Karen Willey, Chair
Lawrence-Douglas County Planning Commission
Lawrence City Hall
6 East 6th St.
Lawrence KS 66044

22 January 2019

We also wish to assure that all newly planned urban development incorporates bikeway infrastructure by intent, so that difficult and expensive future retrofits do not become necessary. In that regard, I have some observations and requests for bikeways consideration in the 23rd Street Mixed Use Development.

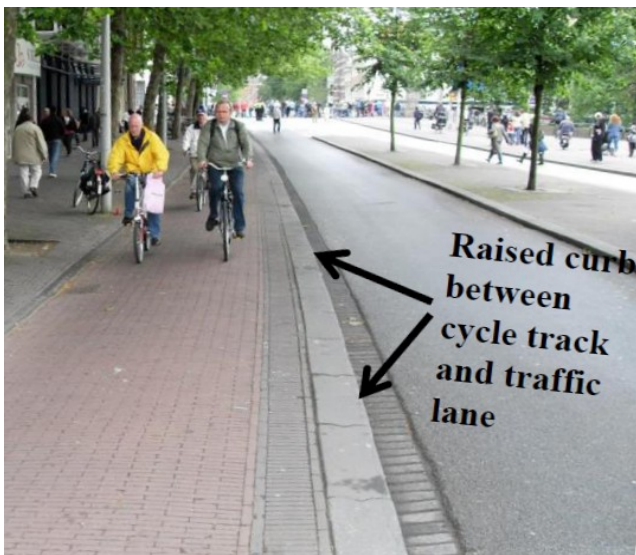
One major north-south spoke passes in immediate proximity to the 23rd Street Mixed Use Development, and should be given particular attention. It extends from Sunnyside Dr. at K.U. south along Naismith Dr. From 23rd St. it extends along the west side of Naismith Dr. to connect with the Naismith Valley Trail that goes all the way to the S.L.T. Trail (part of the Loop). This 2 1/2 mile spoke has a 1/2 mile gap between 23rd St and 19th St. that Lawrence is planning to complete within a year or two.
